December 22, 2023

Amber Wood Hicken
City of Parker Development Review Division
20120 East Mainstreet
Parker, CO 80138

**RE: Parker Pointe F1 Lot 2A, McDonald's – Site Plan, SP23-070
Review Comments 01 Responses**

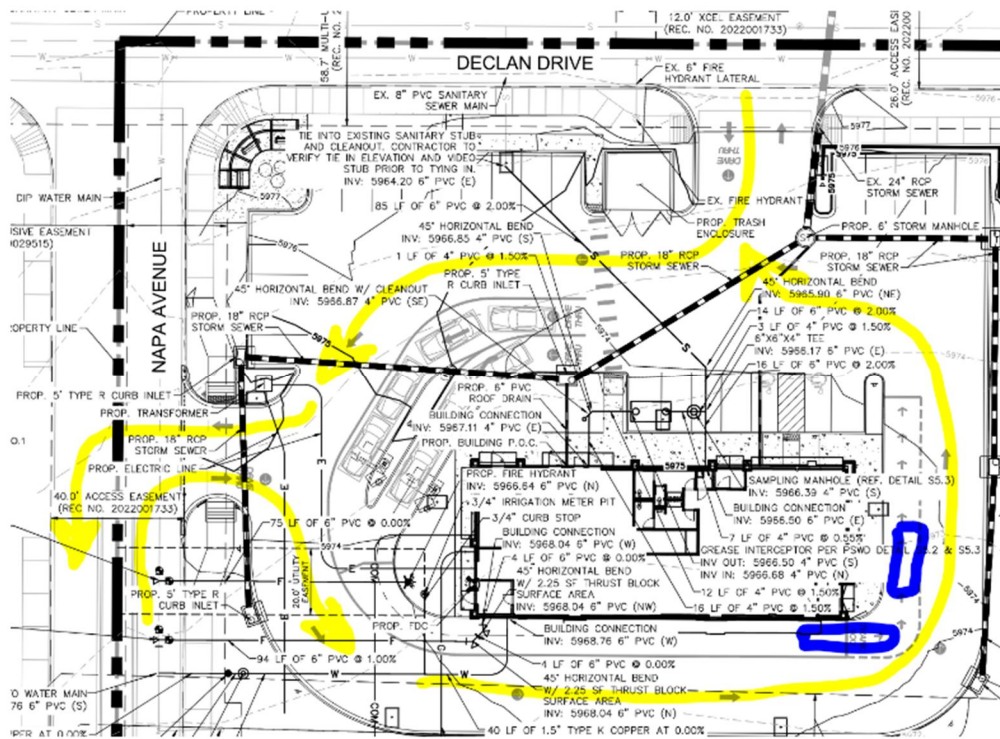
- 3. The applicant shall provide an auto turn analysis indicating that apparatus can navigate all portions of this site; NO PARKING – FIRE LANE signage is required for any portion of the access where the 20-foot clear width requirement cannot be met. In this case, the applicant has provided an auto turn analysis for a portion of the site; the applicant shall update the analysis to include the right in/right out entry on the south portion of the site; see below and address when resubmitting:

Note – the area identified with the two blue rectangles is of particular concern. People tend to not stay within the lines and the 20-foot drive aisle on the south end creates a potential for delays in response specific to staged or waiting vehicles in this area. Ensure that this issue is addressed adequately or provide signage that states NO PARKING OR STANDING – FIRE LANE in this area (area shown on west side of building... south end as well as the south side of the building).

- *Response: No parking signage has been added to the southwest corner of the drive-thru to prevent cars from parking on the curve. A fire truck turn exhibit has been included in the submittal, but the path from the north right-in, right-out access is not able to circle the building. Instead, a path showing a truck entering from the east full access is shown looping the building.*
